RE: **Site Plan Review (SPA 23-0001)** for the construction of a 22,484-square foot multi-tenant commercial building, with associated parking and site improvements. The applicant is requesting waivers to the landscaping standards and parking stall size. Site location is 7749 E M-36; TID 15-25-200-068.

**To:** Planning Commissioners  
**From:** Amy Steffens, AICP  
Planning and Zoning Director  
**Date:** May 31, 2023

**Project address and Description:** **Site Plan Review (SPA 23-0001)** for the construction of a 27,461 multi-tenant commercial building, with associated parking and site improvements. The applicant is requesting waivers to the landscaping standards. Site location 7749 E M-36; TID 15-25-200-068.

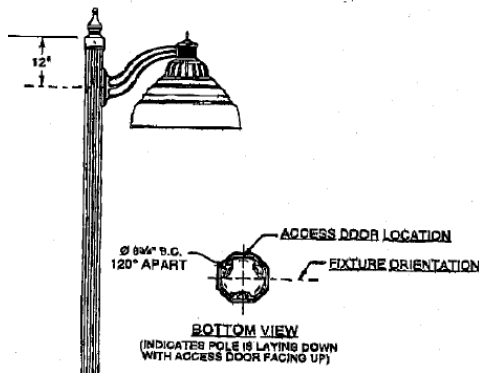
The lighting plan provided is adequate to determine the conformance to the zoning ordinance requirements. However, staff would suggest that the exterior light style does not match the Village Center lighting style that has been installed in various locations throughout the Village Center, most recently at the senior living facility on the south side of M-36 (below).

**Staff Suggestion Condition:** Applicant shall propose an exterior light that is similar to the suggested Village Center lighting and shall re-submit a photometric plan prior to issuance of a land use permit that is specific to the approved lighting style.

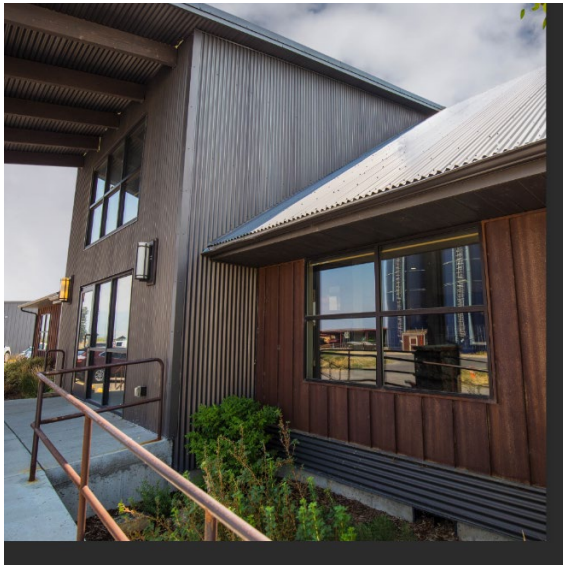
Section 36-73(7) specifies that “For any side of a principal building facing a public or private street, at least 50 percent of the facade shall be constructed of, or covered with, the following materials: brick; fluted or scored concrete block; cut stone, vinyl siding; vinyl siding; glass; or other materials similar to the above as determined by the Planning Commission.” The metal siding would need to be approved by the Commission as an acceptable substitute to the noted materials.

Additionally, building walls over 100 feet in length shall be broken up with a combination of the following: varying building lines, windows, architectural accents, and trees. The only windows on the 292-foot long east elevation are the windows on the tenant space entry doors.

The proposed elevations are uninspired and wholly inappropriate for a commercial structure along a gateway into Hamburg Township that is zoned Village Center. There are multiple ways to add interest to a metal-sided rectangular building. Height and depth articulations, additional windows, and a mix of exterior finishes would break up the expansive east elevation and add aesthetic interest to the south elevation. Staff offers the images below as examples of architectural details that could be used on the proposed building. The Commission should also consider requiring additional finishes on the south and north elevations.

LA1.1

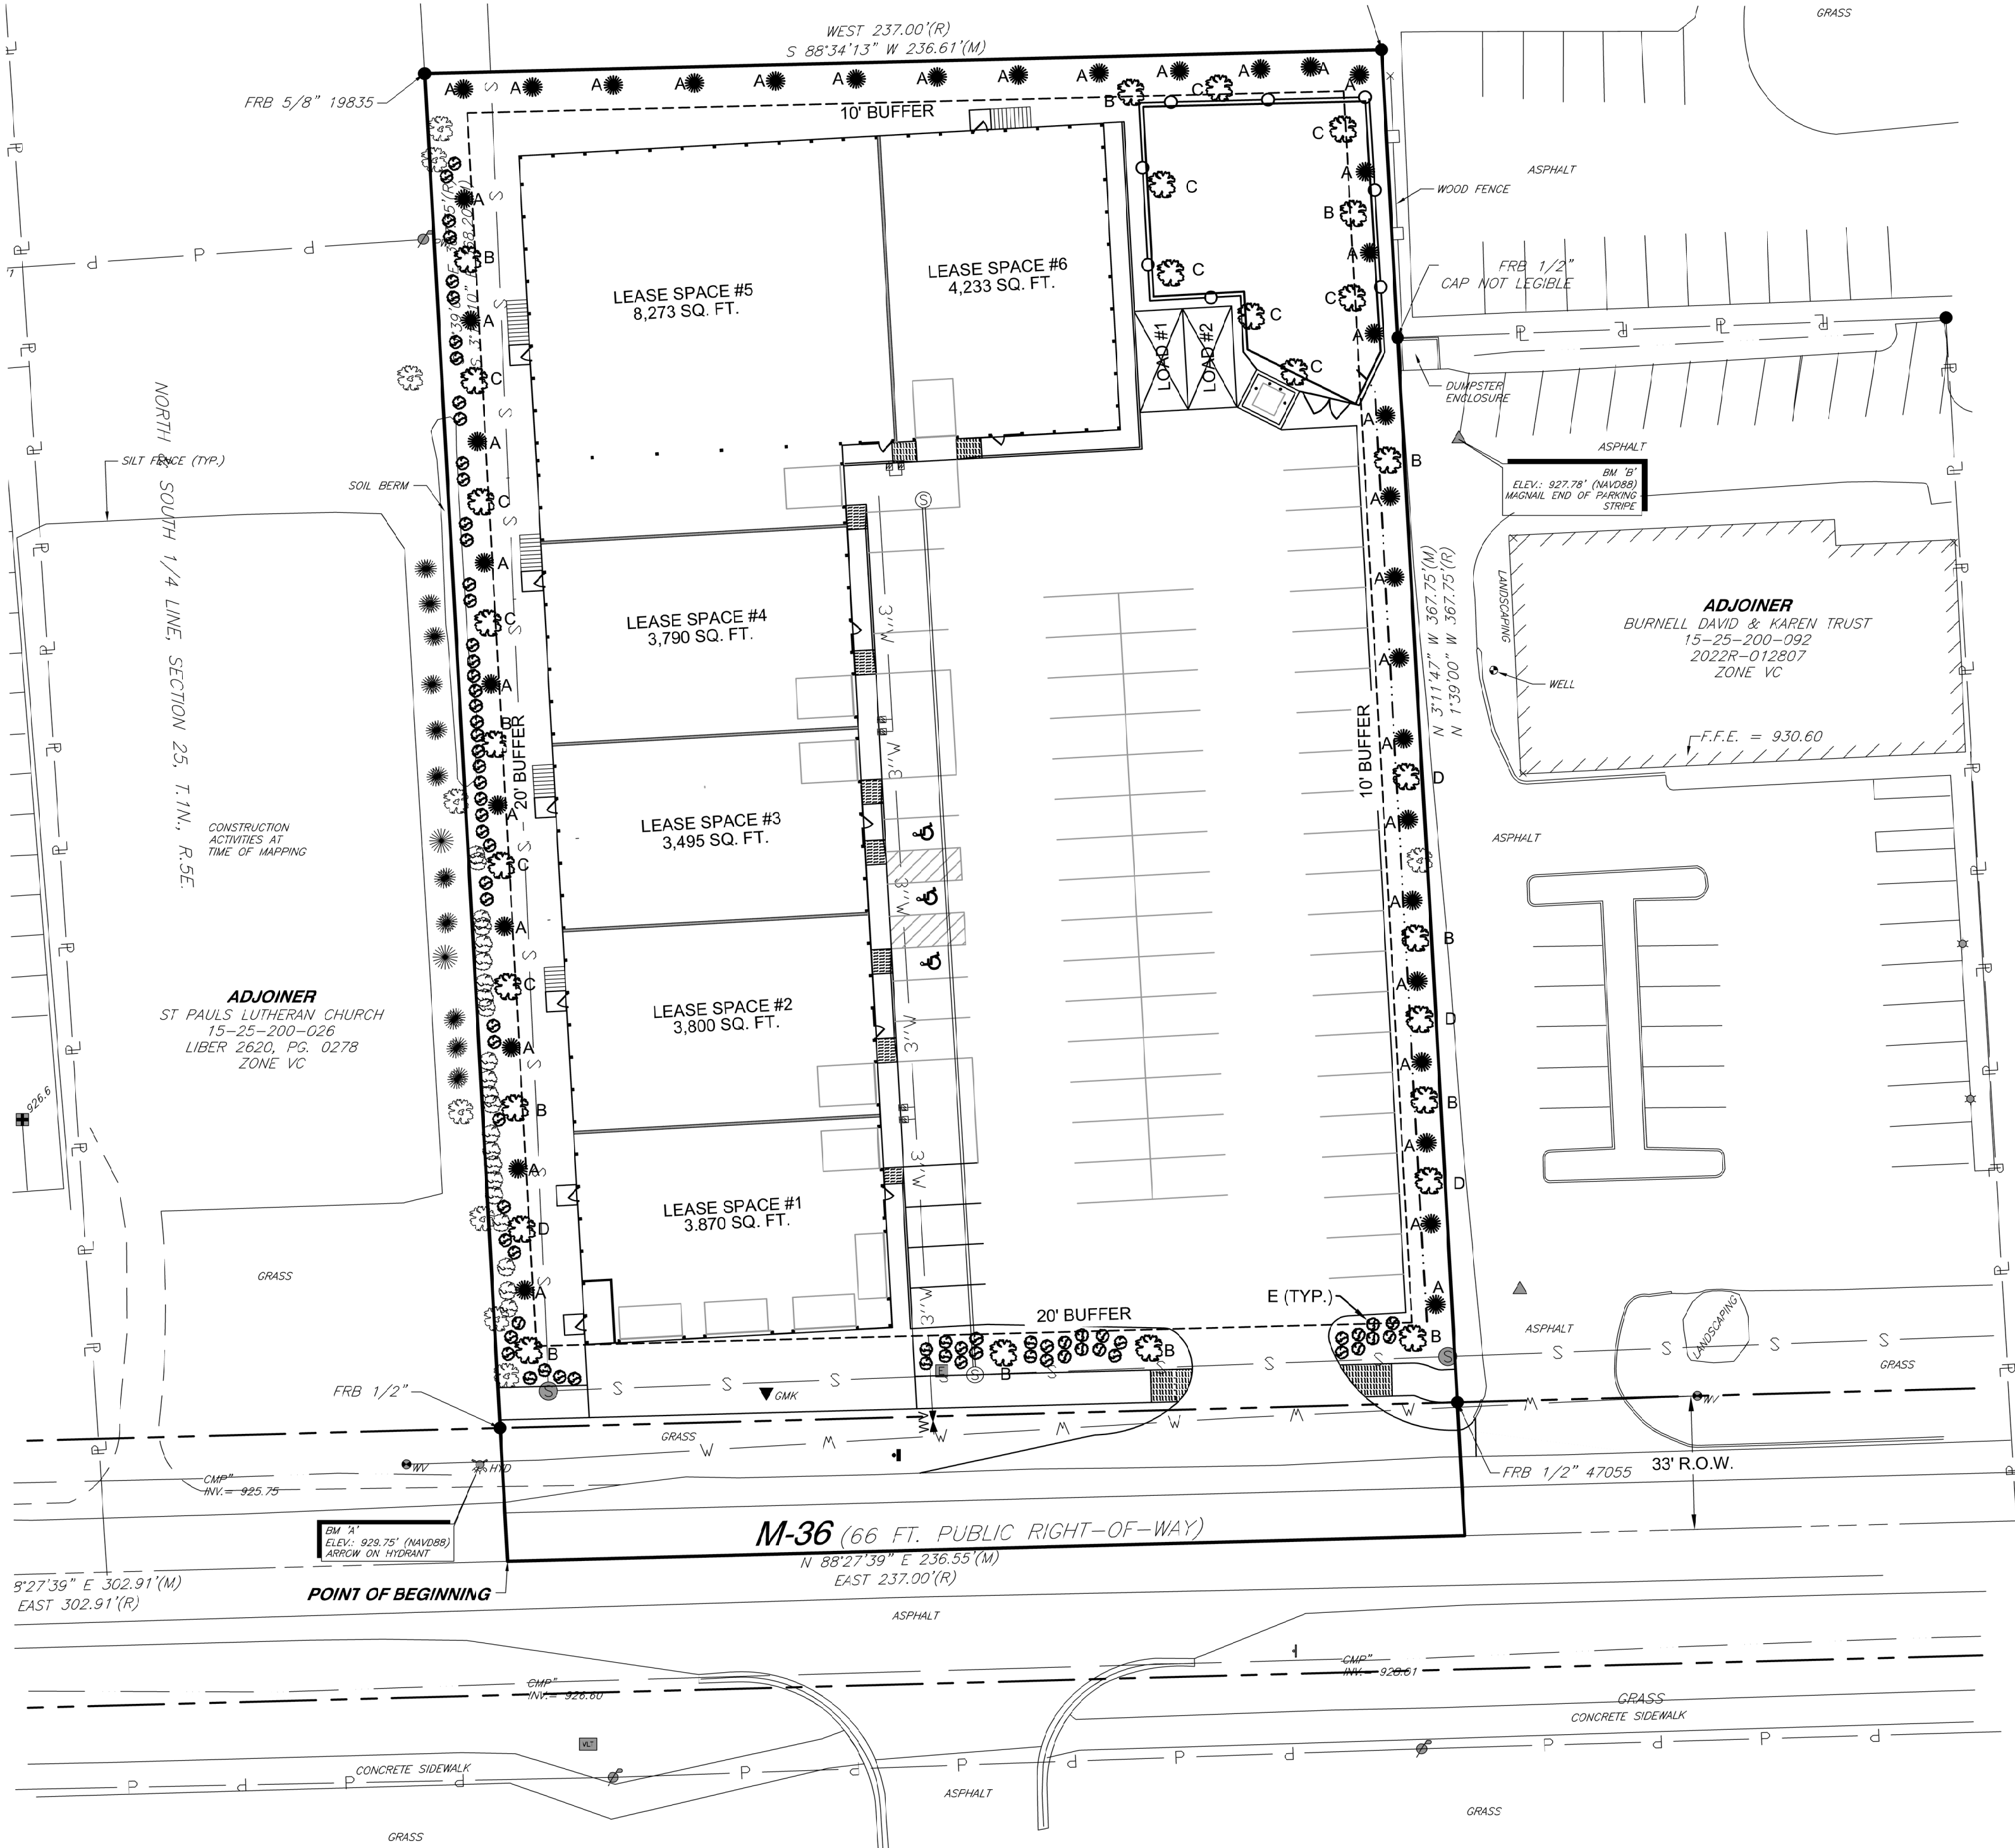
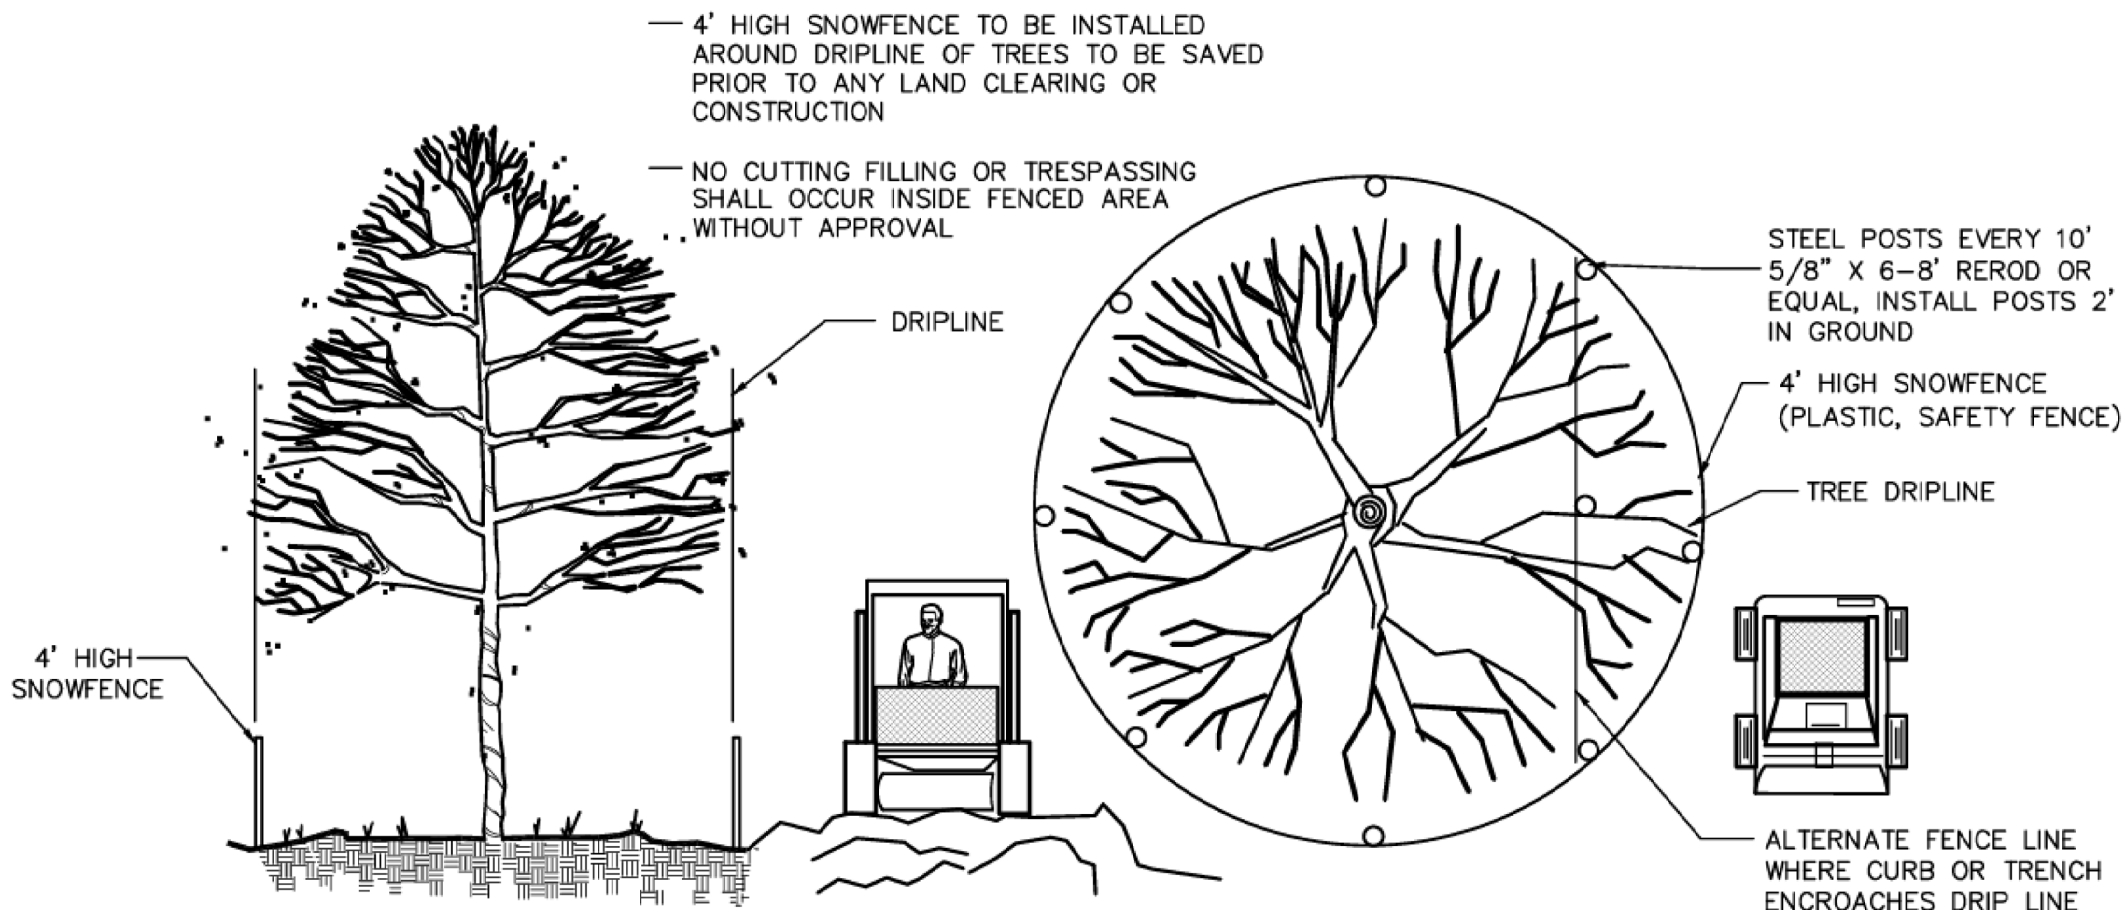
**Staff analysis:** Existing plant material to be saved is not noted on the site plan; tree protection details are included in the site plan.

**Staff analysis:** The proposed row of boxwoods would screen the parking lot from M-36, so long as the height is maintained at three feet, but additional boxwoods should be planted within the east setback to further screen parking from M-36.

**Staff analysis:** One additional tree should be planted along the M-36 frontage in order to comply with this requirement.

**Staff suggested condition:** Tree preservation details shall be delineated on the final site plan.
